Fermi 2 Power Plant
NRC Docket No. 50-341
NRC License No. NPF-43

Subject: Clarification for Request for Additional Information Responses for License Amendment Request to Revise Technical Specification 3.8.1, AC Sources - Operating, Surveillance Requirement SR 3.8.1.12

Response to NRC Clarification Questions

Figure 1

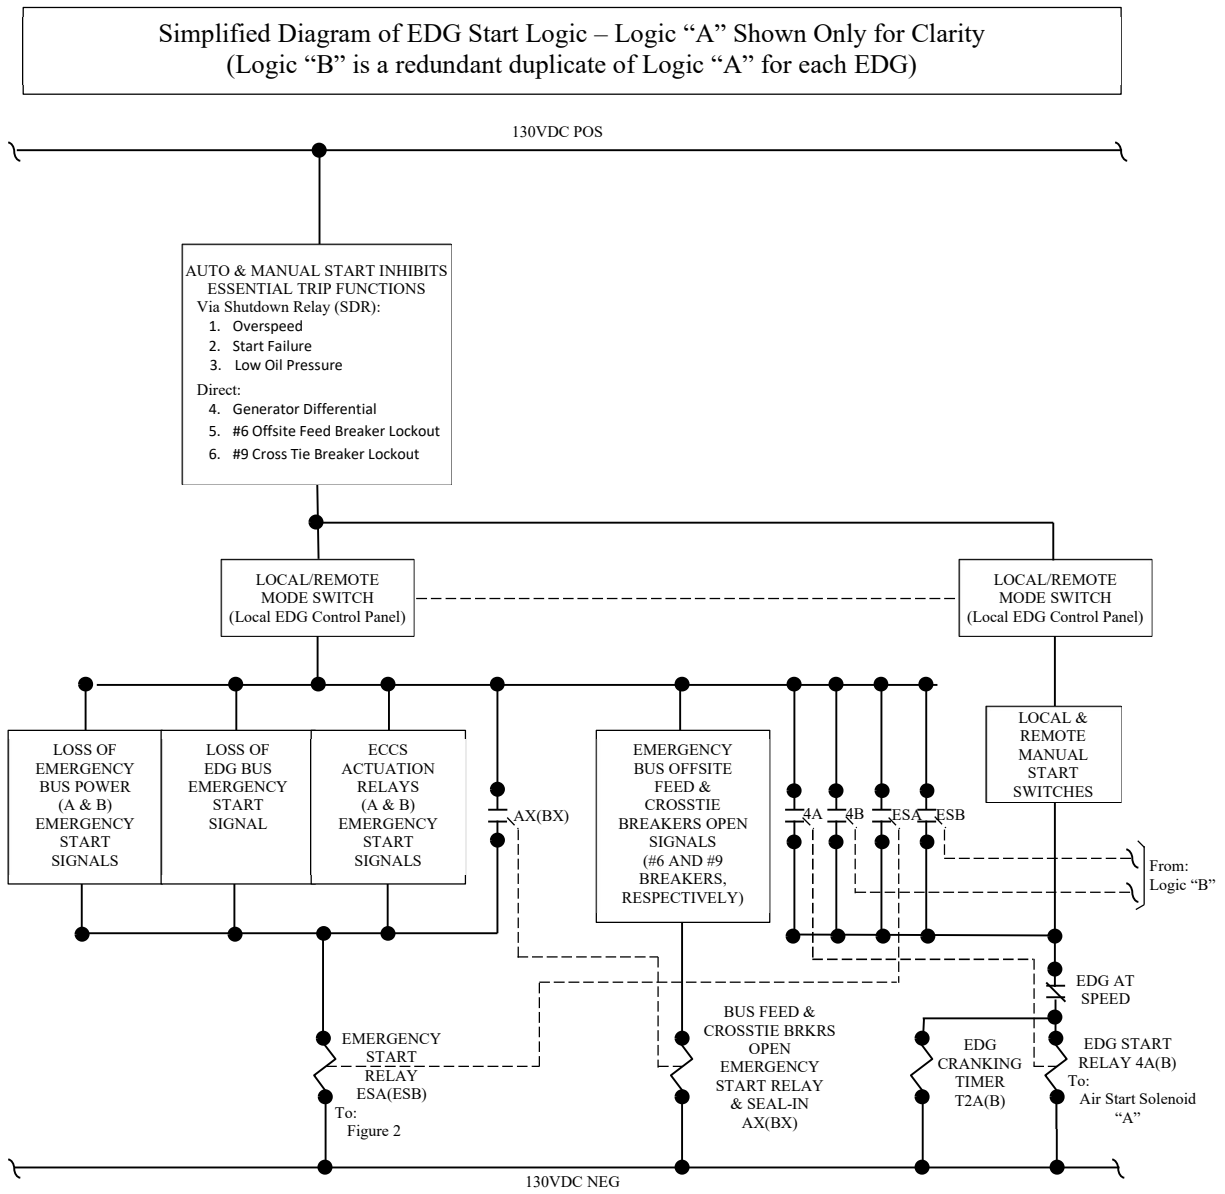
Explain what “reset” means in the context of the above statements.

In the context of the statement, the term “reset” simply means the opposite contact state from trip. The nonemergency trip relay function is automatically bypassed by the emergency start signal. Refer to the following discussion and Figure 1 & Figure 2 for additional information.

Except for the Field, Overvoltage, and Ground non-essential energize to trip functions, the non-essential trip sensors are connected to dedicated sensor relays. After an EDG startup, certain trip parameters are delayed allowing the parameters to normalize at operating conditions because all non-essential trip sensor relays are held in the normally energized, non-tripped state by the associated parameters single sensor contact. The normally closed non-essential trip relay contacts are then combined in a parallel configuration to energize the self-sealing, non-essential trip engine shutdown relay, NCX. The non-essential trips are automatically bypassed by actuating the EDG emergency start signal to energize the redundant Emergency Start relays, ESA & ESB, and open the normally closed contacts of ESA and ESB wired in series (OR) between the common rail of the paralleled non-essential relays trip contacts and the non-essential NCX engine shutdown relay coil to act as an inhibit. Upon activating the EDG Emergency Start signal, the ESA and ESB relays energize and interrupt the non-essential trip contacts to drop-out (if a previous non-essential trip was sealed-in) and inhibit energizing the NCX engine shutdown relay coil. In this manner, all non-essential trip parameters are automatically bypassed by the Emergency Start signal, allowing the EDG to start and fulfill the intended safety function.
